RE: Turkey Point Unit 3 and Unit 4  
Docket Nos. 50-250 and 50-251  
Fourth 10-Year Inservice Inspection Interval  
Response to Request for Additional Information for Relief Request No. 15

**FPL Letter L-2015-172**

**Relief Request No. 15**

**Request for Additional Information (RAI)**

Turkey Point 3<sup>1</sup>  
ESTIMATED EXAMINATION COVERAGE FOR WELD: W04  
LOWER SHELL TO LOWER HEAD RING WELD  
Summary Number: 000400,  
Component ID: 3-WR-31  
Scan Plan Drawing Number: 8068905D Sheets 10 & 13,  
WELD VOLUME COVERAGE OBTAINED: 85%

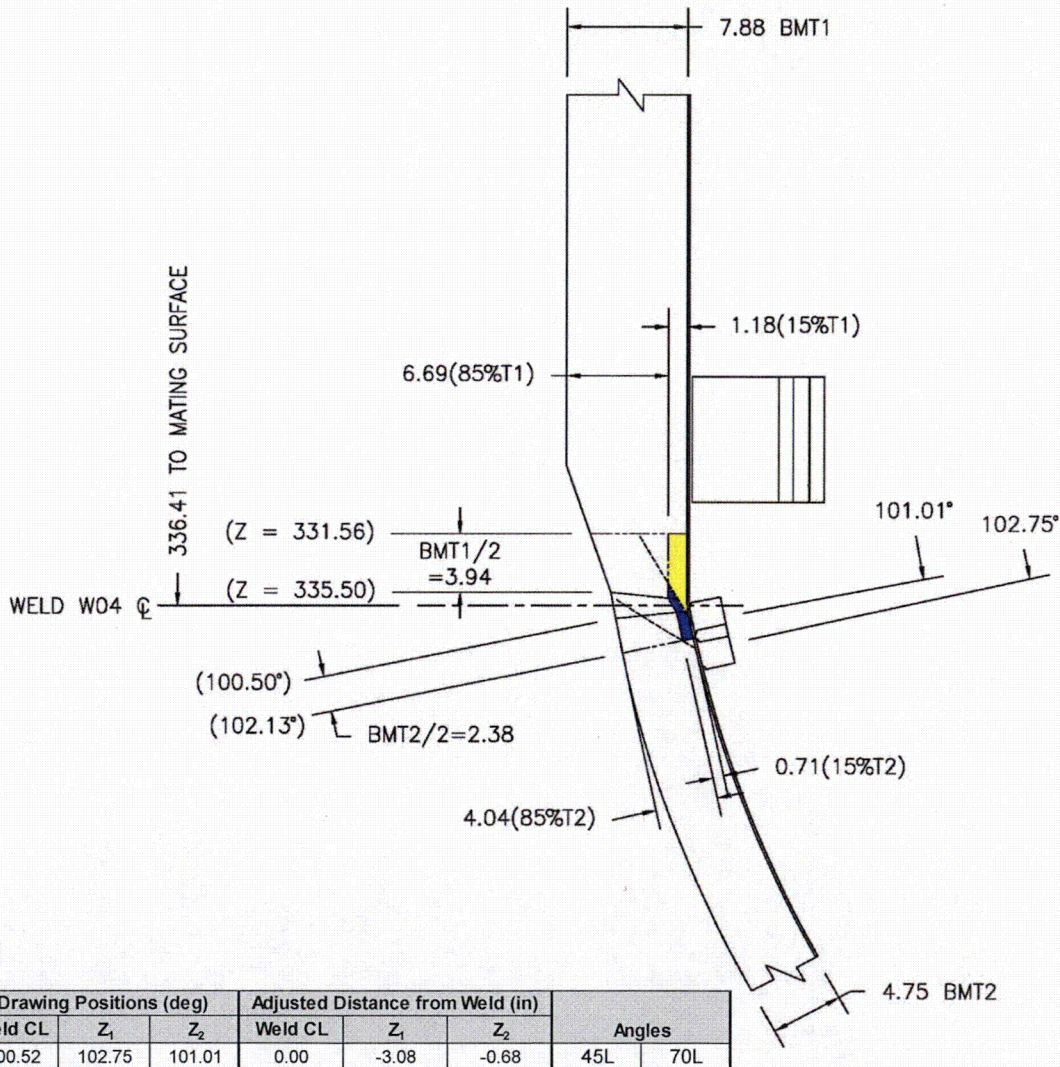
With respect to Figure 2 for Category B-A, Item B1.11, Lower Shell to Lower Head Ring Welds (Weld 3-WR-31 for Unit 3 and 4-WR-31 for Unit 4), provide the following information in a diagram showing: (1) the ASME Code, Section XI required examination volume, (2) the scan angles and axial distances of the search units from the welds used for the examination, and (3) the actual scanned volumes for both the axial and circumferential scan directions. Please refer to the industry/NRC information exchange public meeting held on January 13 -15, 2015 (ADAMS Accession Number ML15013A266), for a discussion of the NRC staff's expectations for the content of an inspection diagram (see Slide 12 for an example).

The following information is provided for the Category B-A, Item B1.11, Lower Shell to Lower Head Ring Welds (Weld 3-WR-31 for Unit 3 and 4-WR-31 for Unit 4):

- (1) The ASME Code, Section XI required examination volume is illustrated on pages 4 through 9 of this enclosure. The examination volume includes the weld and 1/2 "T" of the base material on each side of the weld for the complete through wall thickness.
- (2) The scan angles and axial distances of the search units from the welds used for the examination are provided on pages 4 through 9 of this enclosure. The search unit shown in the illustrations does not reflect the actual size of the UT head configuration. Refer to Figure 1 of the original relief request.
- (3) The actual scanned volumes for both axial and circumferential scan directions are located on page 3 of this enclosure.

Zone Coverage Obtained									
Inner 15%T: 76.7%		Outer 85%T: 86.8%		Aggregate: 85.2%					
Examination Volume Definition									
Weld Length: 497.942 in.									
Area Measurement (axial plane)				Volume Calculation					
Inner 15%T		6.38 sq. in.		Inner 15%T		3176.87 cu. in.			
Outer 85%T		32.80 sq. in.		Outer 85%T		16332.51 cu. in.			
Limitations		Limits scan by:					Compensation(s)		
Core Support Lugs		Restricts UT head movement					Single Sided scans		
Examination Coverage Calculations									
INNER 15%T									
Axial Beam Direction Coverages									
Entry #	Exam. Angle (deg.)	Beam Direction	Area Examined (sq. in.)	Length Examined (in.)	Volume Examined (cu. in.)	Volume Required (cu. in.)	Percent Examined	Limited	Comment
1	70L/45L	Up/Dn	6.38	353.40	2254.69	2254.69	100.0%	No	Coverage between lugs
2	70L/45L	Up/Dn	1.80	161.80	291.24	1032.28	28.2%	Yes	Coverage below lugs
Total Axial Coverage				515.20	2545.93	3286.98	77.5%

**Turkey Point 3<sup>2</sup>**  
**ESTIMATED EXAMINATION COVERAGE FOR WELD: W01**  
**FLANGE TO UPPER SHELL WELD**

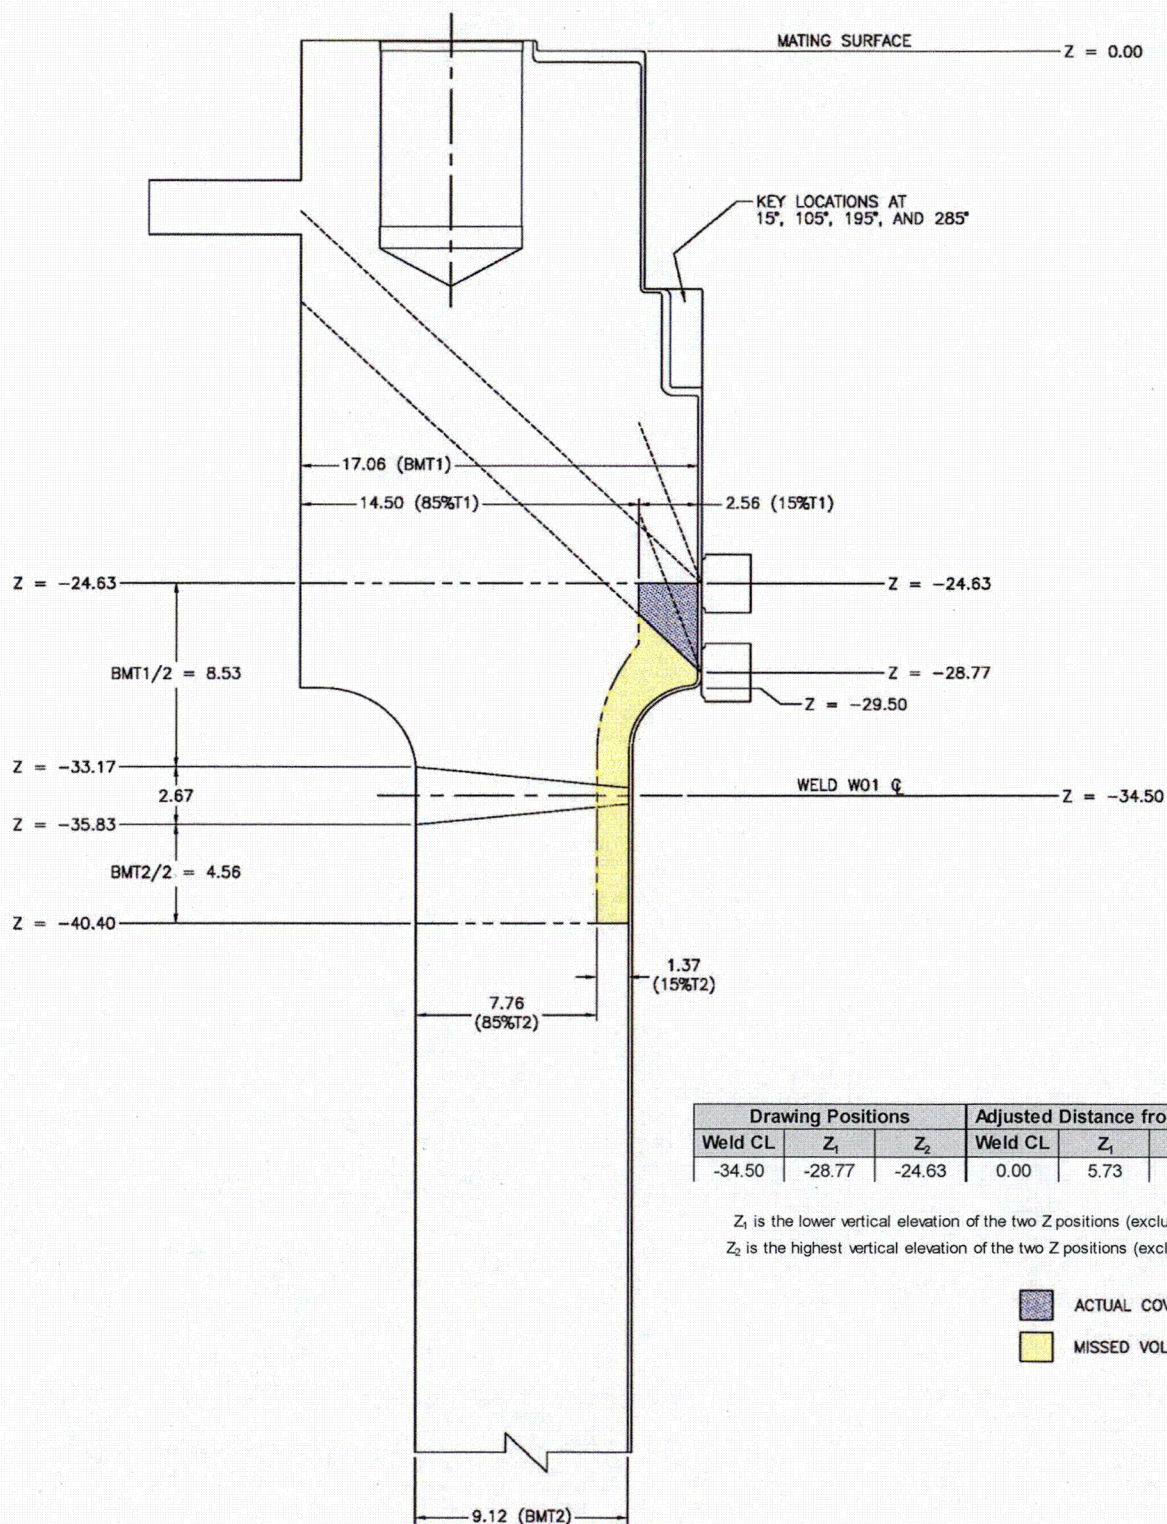
With respect to Figure 5 for Category B-A, Item B1.30, Upper Shell to Flange Welds (Weld 3-WR-18 for Unit 3 and 4-WR-18 for Unit 4), provide the following information in a diagram showing: (1) the ASME Code, Section XI required examination volume, (2) the scan angles and axial distances of the search units from the welds used for the examination, and (3) the actual scanned volumes for both the axial and circumferential scan directions. Please refer to the industry/NRC information exchange public meeting held on January 13 -15, 2015 (ADAMS Accession Number ML15013A266), for a discussion of the NRC staff's expectations for the content of an inspection diagram (see Slide 12 for an example).

The following information is provided with respect to Figure 5 for Category B-A, Item B1.30, Upper Shell to Flange Welds (Weld 3-WR-18 for Unit 3 and 4-WR-18 for Unit 4):

- (1) The ASME Code, Section XI required examination volume is illustrated on pages 12 through 23 of this enclosure. The examination volume includes the weld and 1/2 "T" of the base material on each side of the weld for the complete through wall thickness.
- (2) The scan angles and axial distances of the search units from the welds used for the examination are located on the inspection diagrams on pages 12 through 23 of this enclosure. The search unit shown in the illustrations does not reflect the actual size of the UT head configuration. Refer to Figure 1 of the original relief request.
- (3) The actual scanned volumes for both axial and circumferential scan directions are located on page 11 of this enclosure.

Zone Coverage Obtained									
Inner 15%T: 81.5%		Outer 85%T: 74.4%				Aggregate: 75.5%			
Examination Volume Definition									
Weld Length: 489.49 in.									
Area Measurement (axial plane)					Volume Calculation				
Inner 15%T		29.21 sq. in.			Inner 15%T		14298.05 cu. in.		
Outer 85%T		157.90 sq. in.			Outer 85%T		77290.72 cu. in.		
Limitations		Limits scan by:						Compensation(s)	
Keyways and Irradiation slots. Flange Radius @ID above weld.		Slight reduction in axial and circ scan directions above weld due to interference with keyways and slots at 15°,105°, 195°, 285°, 70°, 80°, 90°, 130°,190°, 310°, 320°, 330° and flange radius 360°						Used single sided scans	
Examination Coverage Calculations									
INNER 15%T									
Axial Beam Direction Coverages									
Entry #	Exam. Angle (deg.)	Beam Direction	Area Examined (sq. in.)	Length Examined (in.)	Volume Examined (cu. in.)	Volume Required (cu. in.)	Percent Examined	Limited	Limitations
